IMMINGHAM EASTERN RO-RO TERMINAL

SUPPLEMENTARY CONSULTATION REPORT

PINS Reference – TR030007
October 2022

Figure 10:
Impact Protection Measures

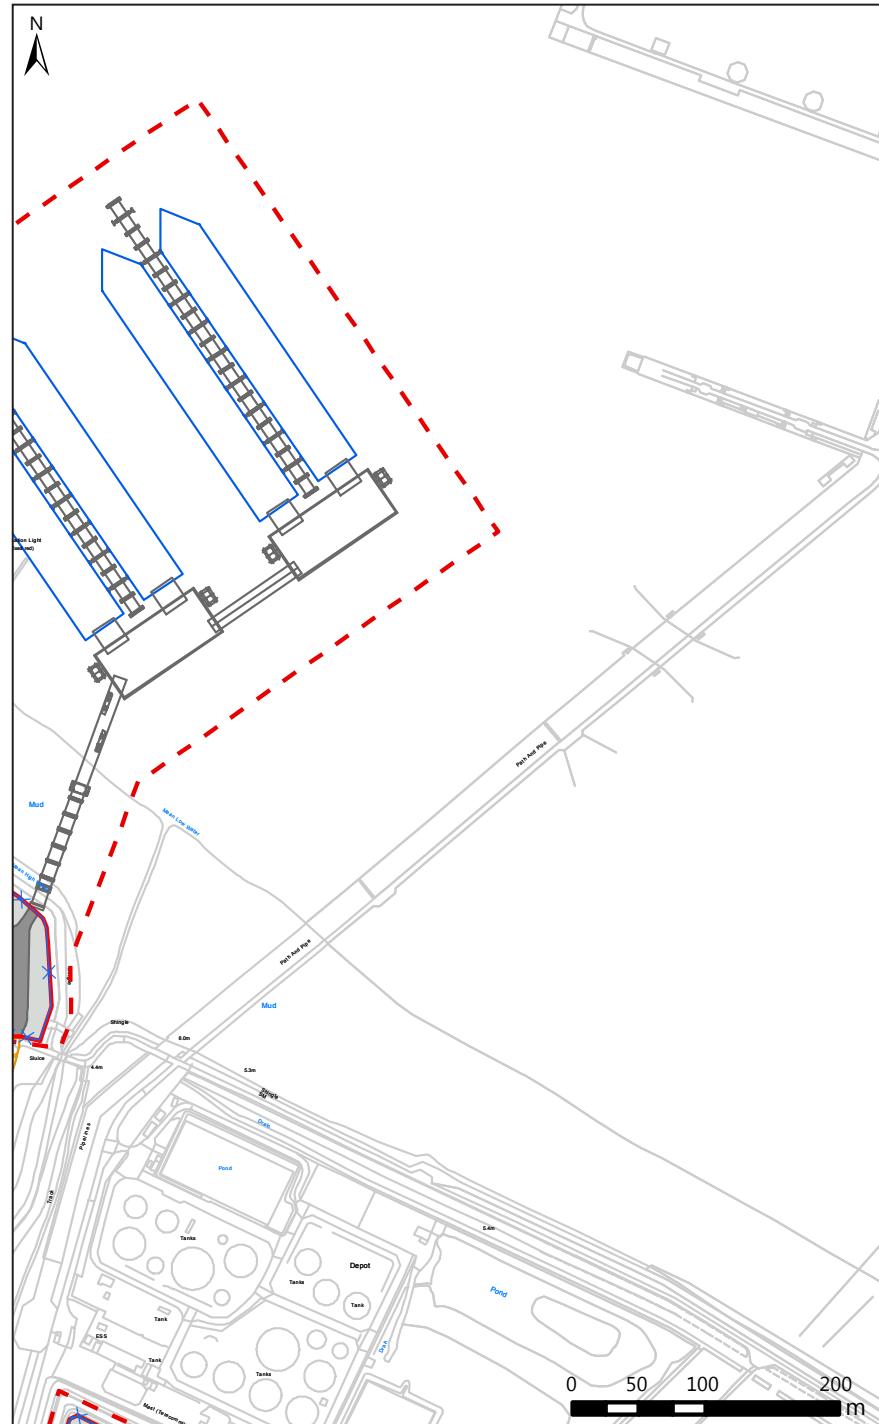
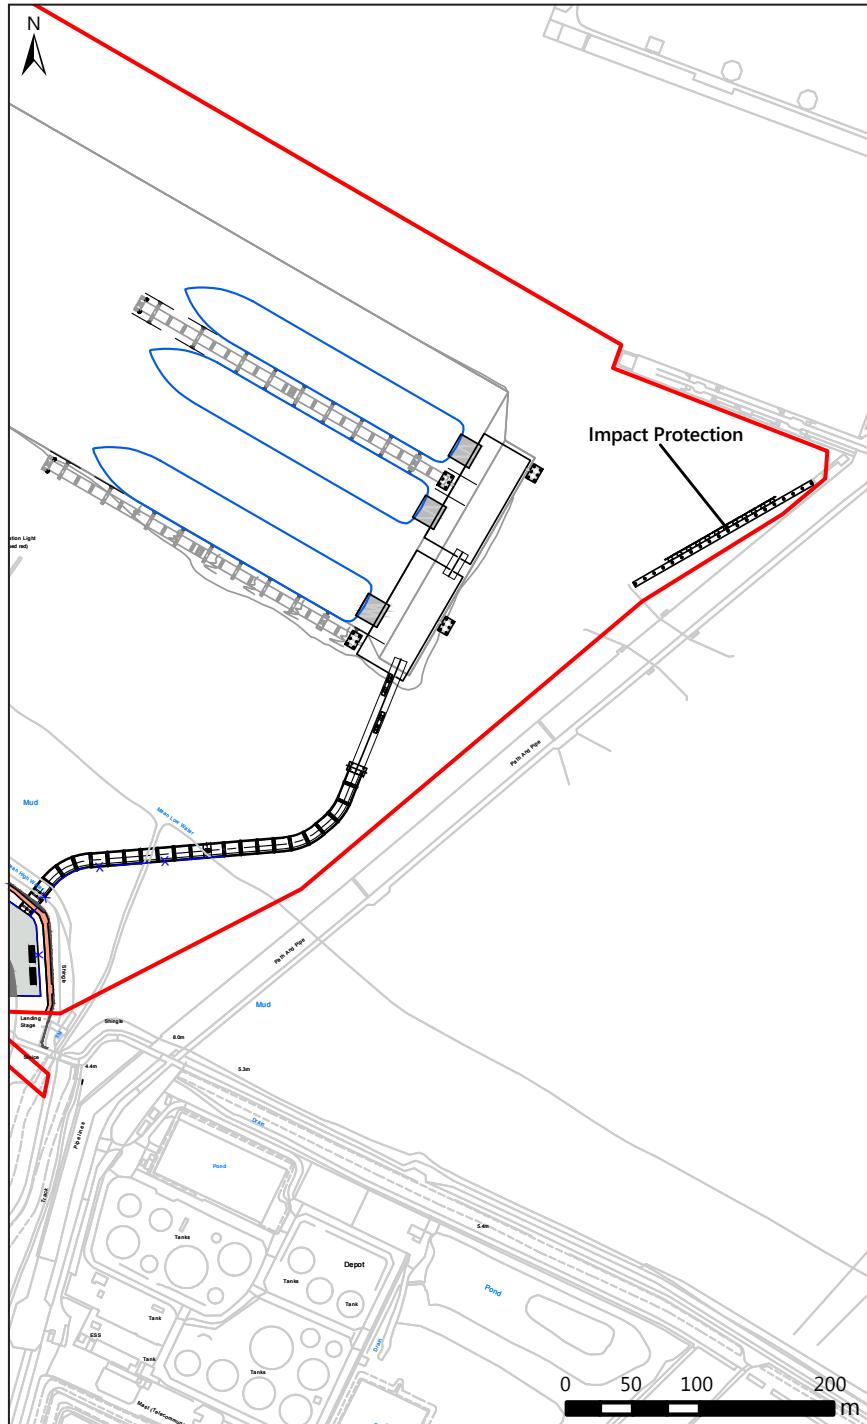
- 16.5 ***Possible impact protection measures*** – The final change made to the project arises directly from representations made by users of the Port. As will be detailed in the IERRT application material, ABP is confident that, following comprehensive risk assessment, the new Ro-Ro facility will be able to operate efficiently and safely without the need for any additional mitigation measures – although it may occasionally be necessary for the Ro-Ro operator to use tugs for a vessel berthing – as is common practice on the Humber Estuary.

impact protection measures, as detailed in Figure 10, should at some time in the future, ABP determine that such measures should be installed.
